# Safety Evaluation Report

## Renewal of the Facility Operating License for the United States Geological Survey TRIGA Research Reactor

License No. R-113  
Docket No. 50-274

U.S. Nuclear Regulatory Commission

Figure 2-4 The GSTR LCC

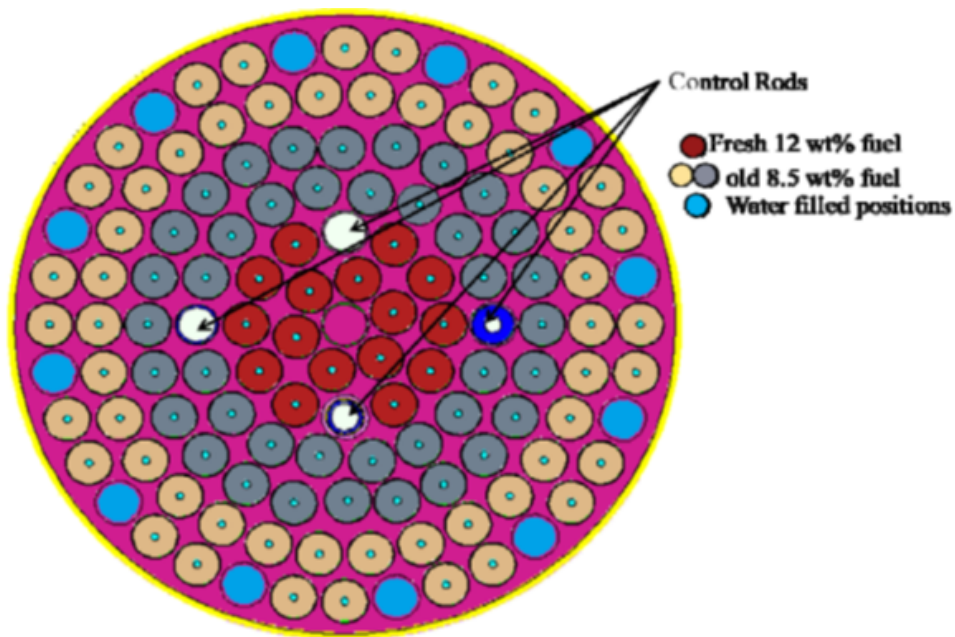
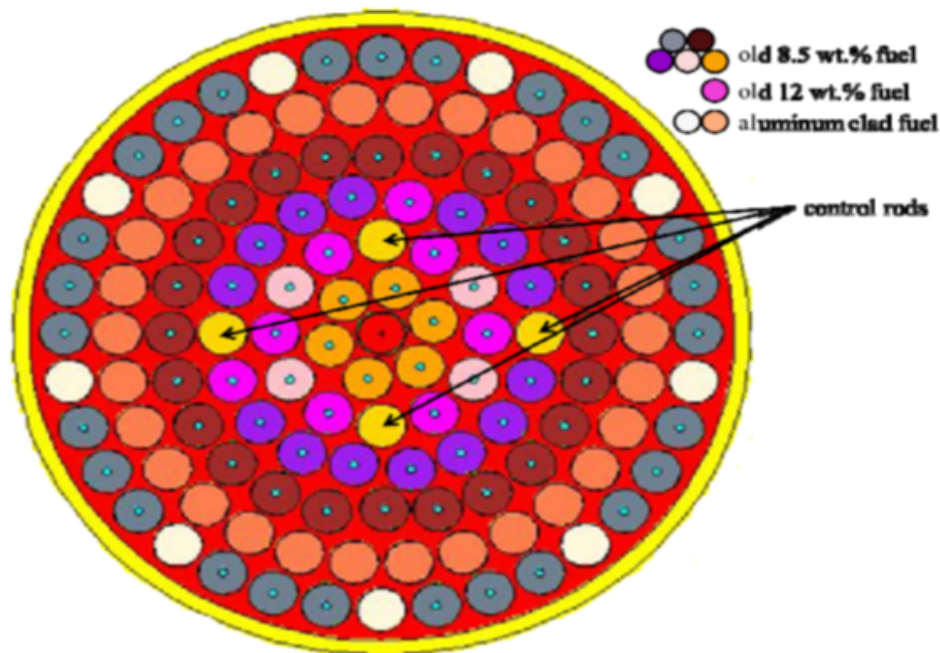
The NRC staff reviewed the GSTR OCC and LCC and finds that these configurations are consistent with the design of the current operating core, and the guidance provided in NUREG-1537, Section 4.5.1, to identify the highest power density of any core arrangement which can be configured for the LCC. The NRC staff finds that the combination of TS 5.3 and the licensee's neutronics analysis are satisfactory to help ensure that control over actual operational core loadings is maintained consistent with the analysis in the SAR and RAI responses. The NRC staff finds that the licensee has acceptably described the LCC and OCC used in the GSTR LRA, including design characteristics and limits, and the constituents, materials, and components for the OCC and LCC. The OCC was reviewed against the current core configuration and available fuel types, and found to be representative of available operating GSTR cores. The LCC is the core configuration that has the highest power density allowable and the licensee uses this configuration to demonstrate the acceptable behavior and performance of the GSTR reactor throughout the updated SAR. The NRC staff reviewed the methodology used by the licensee to calculate the limiting power and finds that the result is comparable to other 1.0 MWt TRIGA reactors. Based on the information above, the NRC staff finds that the GSTR OCC and LCC are acceptable.

Figure 2-7 GSTR Calculated LCC Power Distribution (kWt/fuel element)

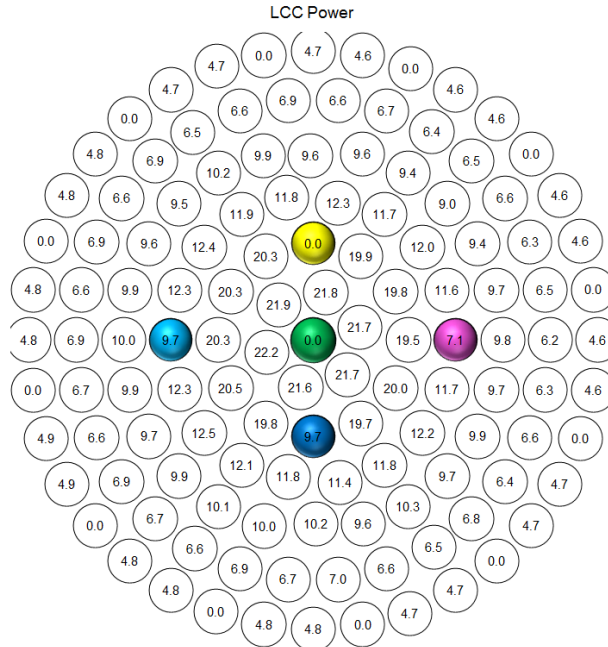
The NRC staff reviewed the licensee’s use of MCNP for the GSTR for core analysis and finds that the MCNP code to be appropriate and reasonable. Based on the information above, the NRC staff concludes that the analysis provided in the GSTR SAR, as updated by its RAI responses, demonstrates that the power distribution of the OCC is bounded by the power distribution of the LCC.

Figure 2-10 Confirmatory Fuel Temperature Coefficient

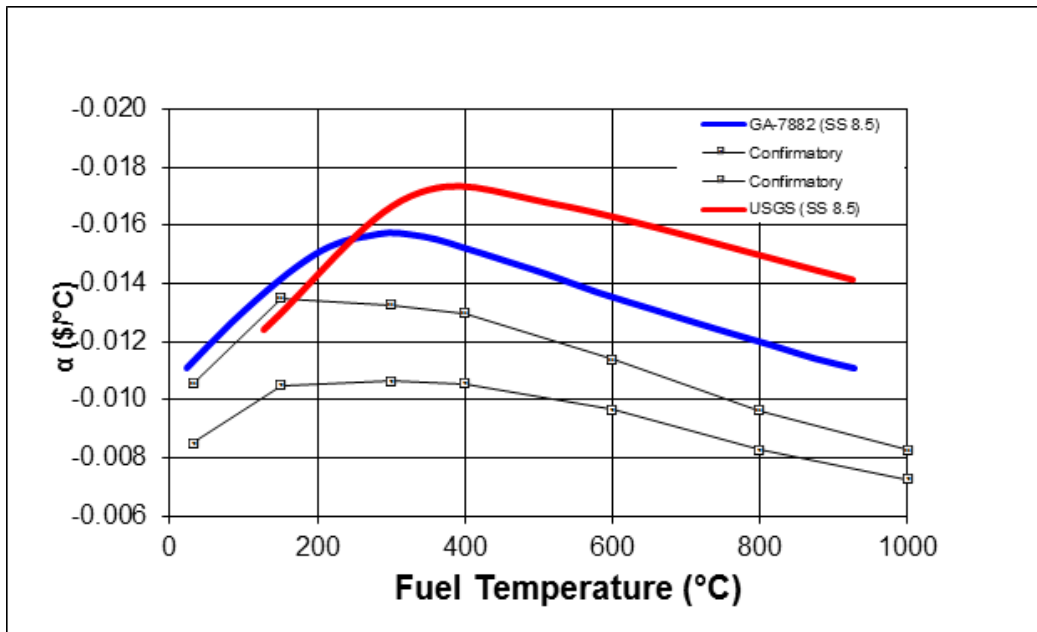
The NRC staff confirmatory calculation results are provided in Figure 2-10 below, which include GA results and the licensee's results. The confirmatory analysis performed using WIMS-ANL utilized a cross-section library derived from Evaluated Nuclear Data Files (ENDF)/B-VI that was developed specifically for RTRs, and thus more representative of expected behavior than the GA-7882 values.

The values obtained in the NRC staff's confirmatory analysis are from unit cell calculations that do not credit the additional negative reactivity from core leakage effects. The licensee analysis includes these effects and the NRC staff accepts these results as being representative of expected GSTR behavior. Based on a review of the licensee's FTC analysis, and in comparison to GA and confirmatory calculations performed by the NRC staff, the NRC staff finds that the FTC analysis performed by the licensee is consistent, follows the same order and trend, and is acceptable for use in safety analysis models used to support analysis provided by the licensee for the GSTR license renewal.

Figure 2-11 Schematic of the subchannel used for DNBR analysis

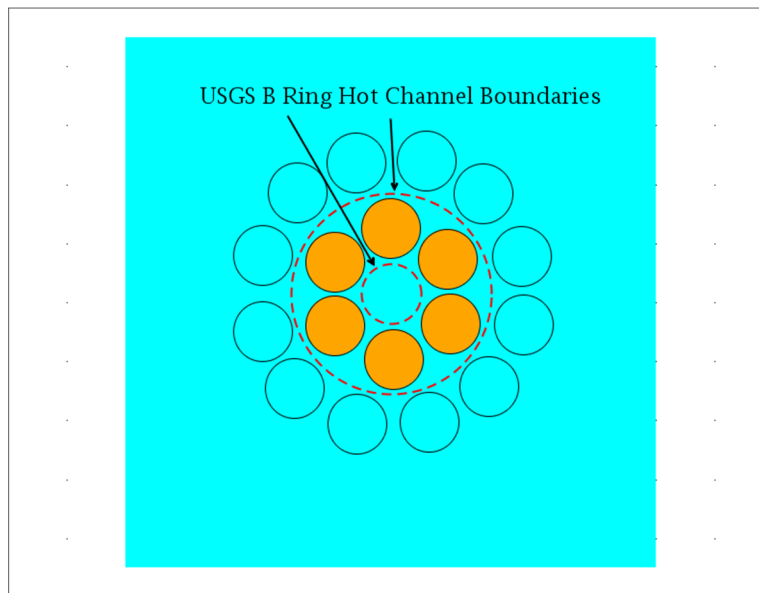
The NRC staff noted the significant power density increase for the B and C rings in the LCC compared to the current OCC (operating at 915 kWt) as shown in Figure 2-8 (Ref. 32). The NRC staff finds that the power density increase would also be expected for the OCC core scaled up to the LSSS power of 1.1 MW. The NRC staff finds that the LCC also has a qualitatively different radial power profile than the OCC. The highest power rods are in the B ring of the proposed LCC and they are in the C ring of the OCC.

The RELAP5 model used by the licensee was based on the average flow area and hydraulic diameter for the B ring of the circular core arrangement of fuel elements. As seen in Figure 2-7 of this SER, the B ring contains the highest power fuel elements in the LCC. Using the average hydraulic conditions for the B ring provides some measure of the thermal margins but, the NRC staff finds that it does not analyze the limiting sub-channel conditions as has been traditionally done in TRIGA safety analysis (Ref. 63). The power to flow area ratio is significantly higher for the triangular shaped sub-channels between the B and C rings and between the B ring and the central thimble than it is for the B ring average quantity. A summary of the geometric

Figure 4-1 GSTR Analysis of a \$3.00 Pulse

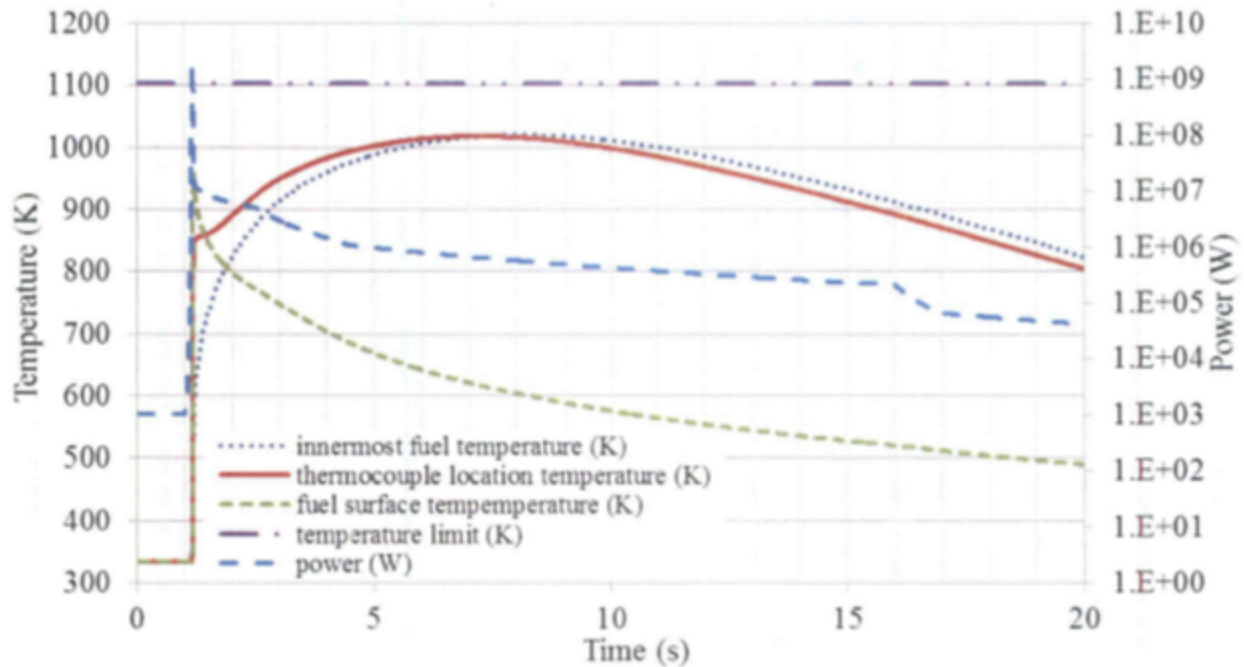
The licensee's RELAP model results are provided in Figure 4-1, and Table 4-8 below, for various pulse reactivity insertions. In all cases, including the maximum reactivity value of \$3.00, the maximum fuel temperature attained remains below the pulse fuel temperature limit of 830 °C (1,526 °F, or 1,103 °K) as shown in Figure 4-1 below).

Figure 1: Administrative Structure

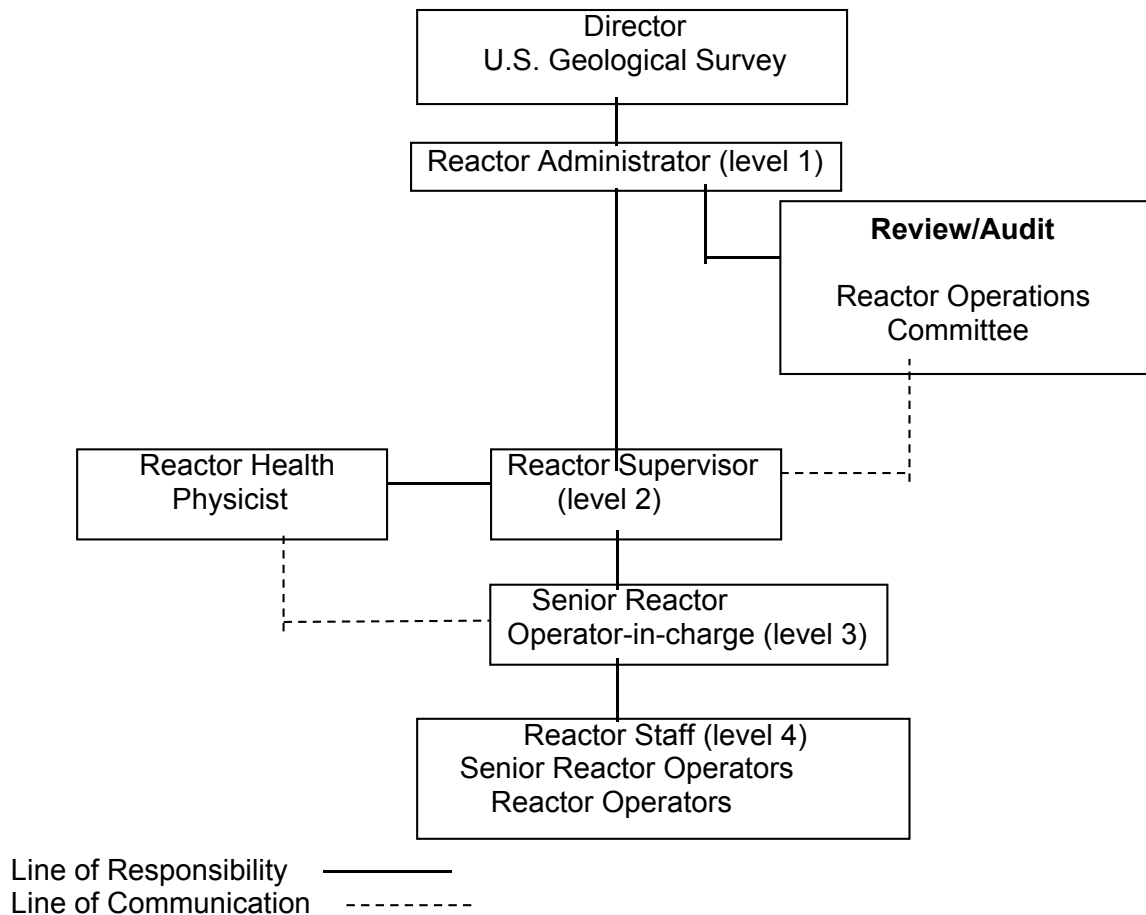
TS 6.1.1 helps to ensure that the GSTR organization structure is delineated, as described in TS 6.1.1, and in Figure 5.1 below (GSTR TS Figure 1). The NRC staff noted that in the proposed Figure 1, the Radiation Safety Committee Chairperson and Health Physics Staff have been replaced with Reactor Health Physicist. In its response to RAI No. 29.d, the licensee states that as a result of License Amendment No. 12, which allowed the transfer of non-GSTR produced byproduct and source material from the USGS Materials License No. 05-01399-08 to the USGS GSTR Facility Operating License No. R-113, certain licensed material is no longer under the purview of the Radiation Safety Committee Chairman. The oversight of the Radiation Safety Committee was transferred to the ROC. The Reactor Health Physicist reports to the Reactor Supervisor (level 2) and has a line of communication to the SRO in-charge (level 3). The NRC staff reviewed TS 6.1.1, Figure 1 and finds that Figure 1 identifies the reporting and communication relationships between the organization units for the GSTR facility and is consistent with the guidance provided in NUREG-1537 and ANSI/ANS 15.1-2007. On the basis of the information above, the NRC staff concludes that TS 6.1.1 and TS Figure 1, is acceptable.
